Subject: Docket Nos. 50-361 and 50-362
Supplement 1 to Amendment Application Nos. 136 and 120
Change to Technical Specifications 3/4.3.2,
"Engineered Safety Features Actuation Systems,"
San Onofre Nuclear Generating Station, Units 2 and 3

SUPPLEMENT 1 TO PCN 429

DESCRIPTION AND SAFETY ANALYSIS
OF PROPOSED CHANGE NPF-10/15-429, Supplement 1

FIGURE 1

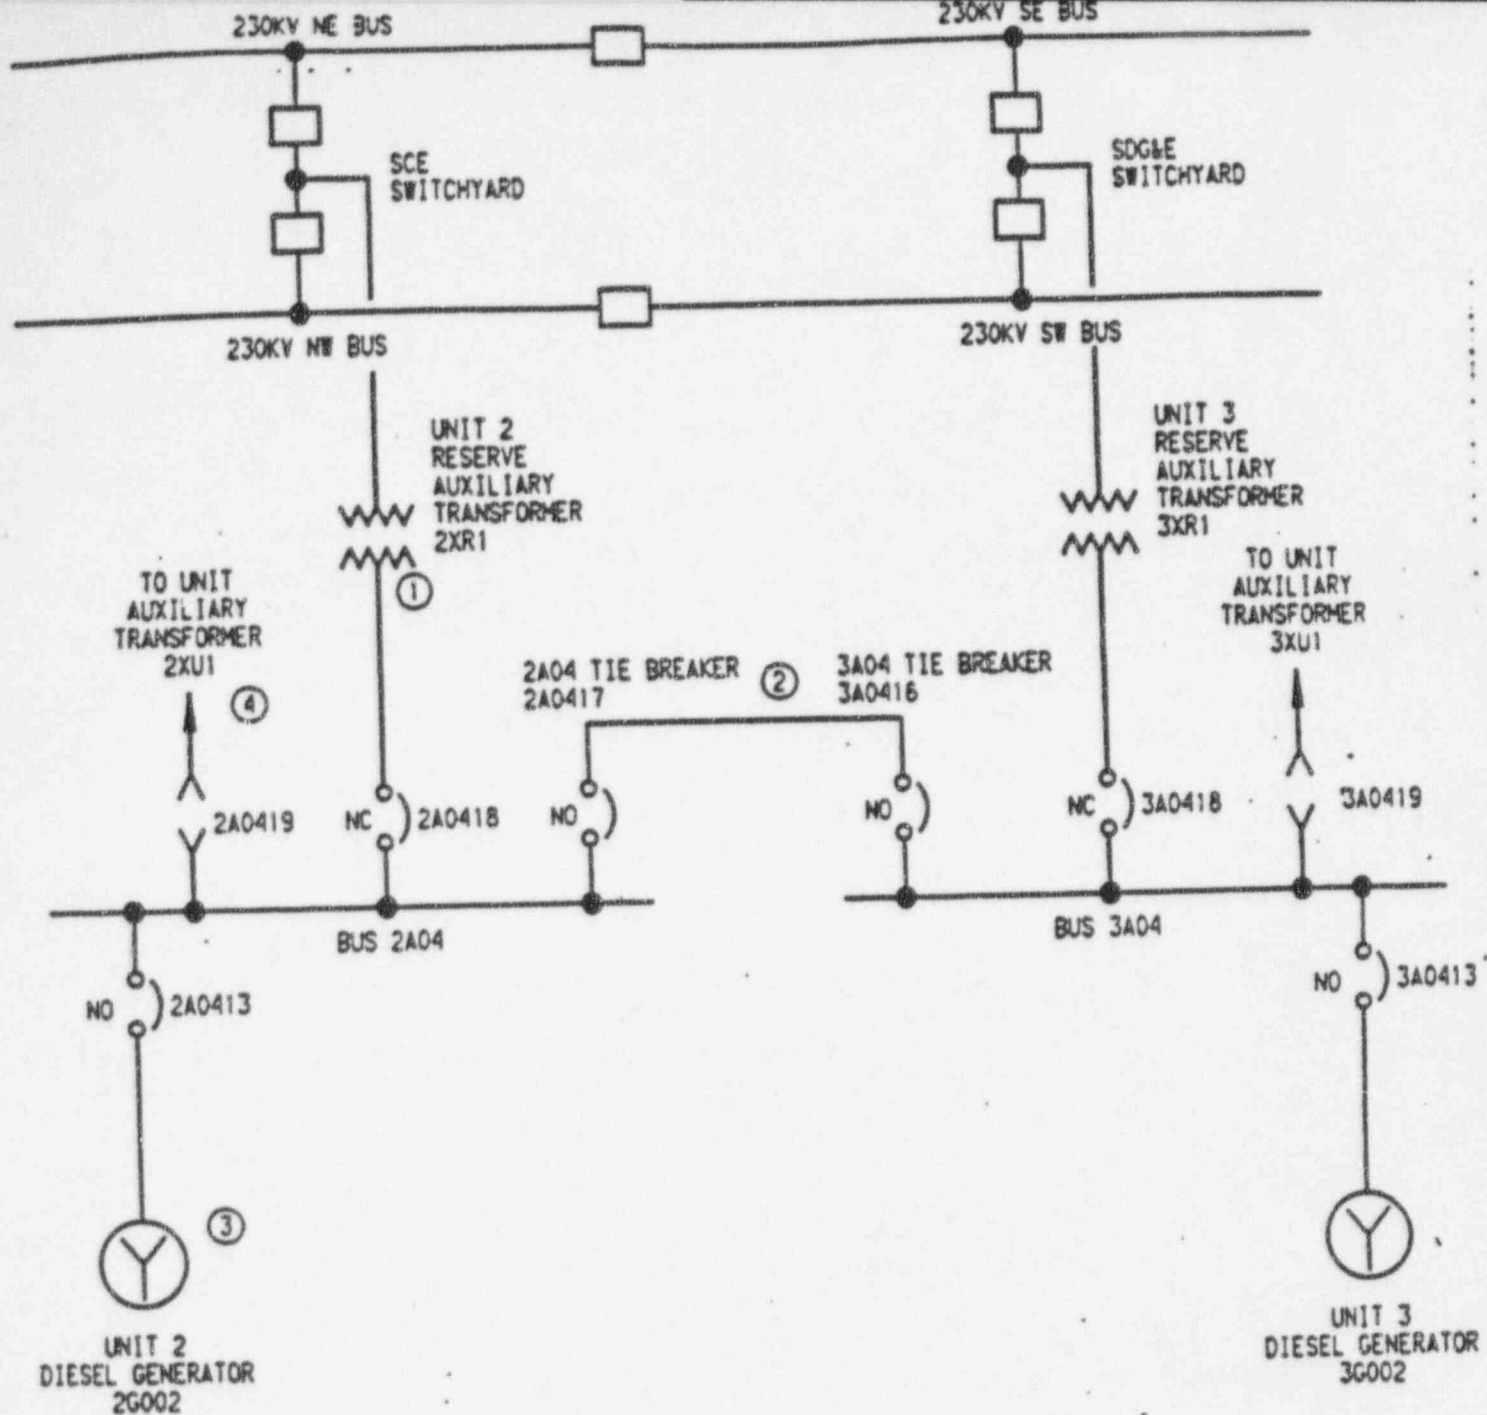
In order to provide more reliable protection against a degraded grid and also to allow the 4.16 kV Class 1E buses of the affected unit to go directly to the standby power source in case of a SIAS with a loss of voltage or degraded voltage condition, SCE is planning to modify the existing LOVS logic and install a separate degraded voltage protection scheme. The logic diagram for the new configuration is shown in Figure 1.

The degraded voltage condition will be detected by new definite time delay solid state relays 127D1, 127D2, 127D3, and 127D4. These relays will be connected to the same set of bus potential transformers as the existing relays 127F1, 127F2, 127F3, and 127F4. The new 127D relays are set at 4228 V, with a definite time delay setting of 2.0 seconds. This voltage setting will assure adequate voltage at the terminals of all engineered safety features equipment based on a switchyard minimum allowable voltage of 218 kV. The voltage setting of 4228 V is below the voltage normally expected at the 4.16 kV level (4360 V or above) with switchyard voltage of 230 kV. Therefore, under normal operating conditions a spurious actuation is not expected.

The new relays, in conjunction with the timing relays 162S1 and 162T1, 162S2 and 162T2, 162S3 and 162T3, and 162S4 and 162T4, will provide the Degraded Grid Voltage with SIAS Signal (DGVSS). The voltage and time delay settings are such that a sensing window will open with a time delay of approximately ~~4.3~~ 4.3 ± 0.19 seconds after initiation of SIAS. This window will remain open for approximately ~~1.5~~ 1.25 ± 0.40 seconds, during which time a DGVSS will be initiated if a degraded voltage condition is established. Upon initiation of the DGVSS, the 4.16 kV Class 1E buses will be transferred directly to the standby power source rather than to the alternate preferred power source, which is likely to also be experiencing a degraded voltage.

The same 127D1, 127D2, 127D3, and 127D4 relays are also used for sustained degraded voltage protection when the diesel generator is not supplying the 4.16 kV Class 1E bus. A Sustained Degraded Voltage Signal (SDVS) is generated with the associated timing relays 162D1, 162D2, 162D3, and 162D4 within ~~135~~ 134.2 seconds so that permanently connected class 1E equipment will not be damaged. If a SIAS signal is present, SDVS will transfer the 4.16 kV Class 1E buses directly to the standby power source. If a SIAS signal is not present, SDVS will transfer the 4.16 kV Class 1E buses to the alternate preferred power source. If the alternate source is not available, the buses will transfer to the standby power source.
